Office Action Summary

10/566,260

UEBELHART, BAUDOUIN
ERNEST

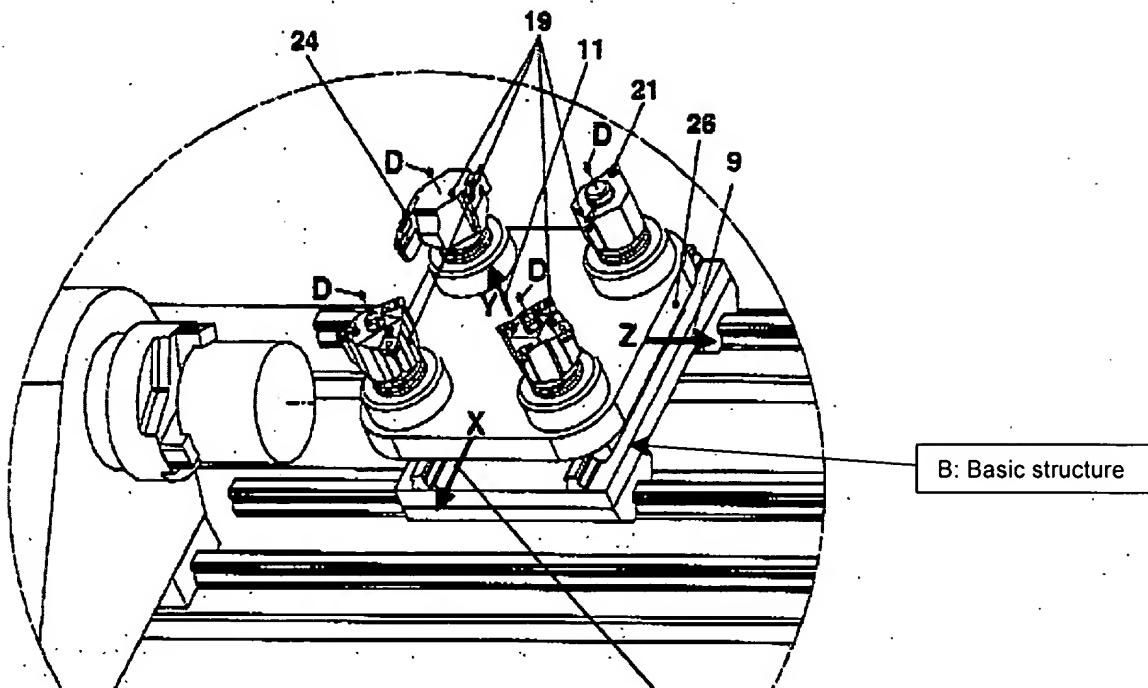
Claims 1-4 and 6, as best understood, are rejected under 35

U.S.C. 102(b) as being anticipated by Maier (US Pub. No. 2002/0170396).

Regarding claim 1, MAIER teaches a tool support provided for machining a work piece having a spindle (4) with axis (3), a basic structure (B: see figure below), a slide (26) mounted on said basic structure which is displaceable (X-

axis) in a controlled manner transversely to the spindle axis, two tool holders (19) mounted parallel to each other on said slide for holding different tools ('396, figure 6). Furthermore, MAIER teaches, each tool holder (19) can be brought into use individually (i.e. tool holders are displaced selectively into and out of the working position) ('396, page 4, paragraph 47). Note: it is old and well known that drive means are used for moving items in a machining environment, in this case the slide and the tool holders move simultaneously along axis X). Furthermore, regarding claims 2 and 3, MAIER teaches, said basic structure being mounted on a tool slide which is displaceable along an axis (Z-axis), which is in the same parallel to the spindle axis (i.e. along the spindle axis) ('396, figure 6).
